State of New Mexico
Energy, Minerals and Natural Resources Department

Oil Conservation Division
UIC Program

Copy of Division e-mail correspondence to Apache concerning the use of dual-packer systems in waterflood operations at:

Submitted for the record by P. Goetze, Engineering Bureau, 05/10/2017

WELL DIAGRAM (CURRENT CONFIGURATION)

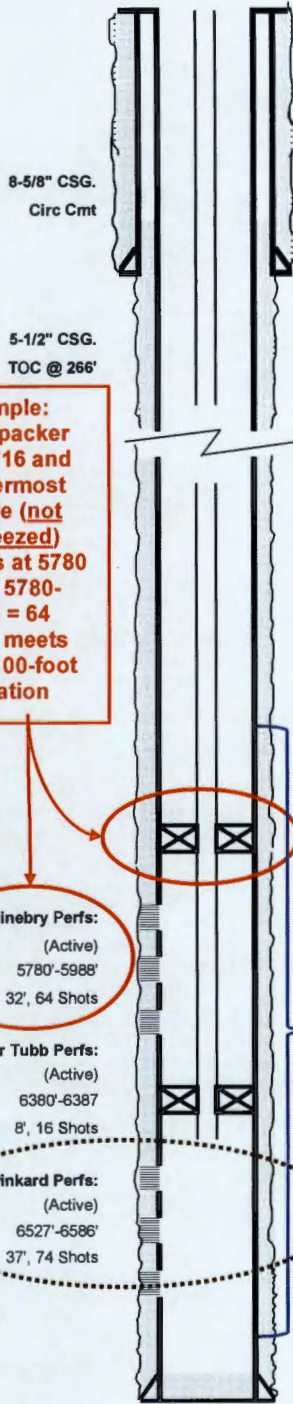
The only compliance issue becomes the "100-foot" setting distance. Using the language in R-12981 [Ordering Paragraph (12) with "*a seal bore assembly set within 100 feet of the uppermost injection perforation*" versus WFX-857 wording of "*packer located within the 100 feet of the injection intervals*"] and after discussion with District personnel who are responsible for UIC inspections, the upper or first packer would be the packer setting to assess compliance with the order. The distance between this packer's setting depth and the uppermost active perforations would be the test for setting within 100 feet (see attachment for example of WBDU #137). The uppermost active perforations will be the Blinebry perfs which are still "active", in this usage – have not been sealed off by casing or squeezed with cement, even though the EOR activities are focused on the deeper Drinkard perforations. So for the example provided with WBDU #137, no exception would be for the 100-foot distance.

Example:
Top packer
at 5716 and
uppermost
active (not
squeezed)
perfs at 5780
feet: 5780-
5716 = 64
feet; meets
the 100-foot
limitation

Summary: Division would approve the use of dual packer assembly (without additional remedial cementing or casing) in all three EOR projects as long as the existing well construction can be used with compromise to the well's integrity and the use is within the limits of the respective Unitized Interval. Where there is an issue with the packer setting and distance to the uppermost perforations, these will be handled on a case-by-case basis with the opportunity for the issuance of Packer Setting Depth Exception letters by Division to resolve these items. Additionally, the Division is recommending the following guidance with dual-packer assembly use:

1. The dual-packer assembly must be set within the defined interval (Unitized Interval) for each respective EOR project. If the upper packer is not within the upper limit of the Unitized Interval, then an exception through an order or letter request must be submitted to the Director (hopefully following discussion between Apache and the Division to review the situation).
2. The MIT requirements [for testing prior to returning to operation] are still in effect if either packer is re-seated or relocated.
3. Apache shall provide a final construction diagram with the installation of any dual-packer assembly approved by District.
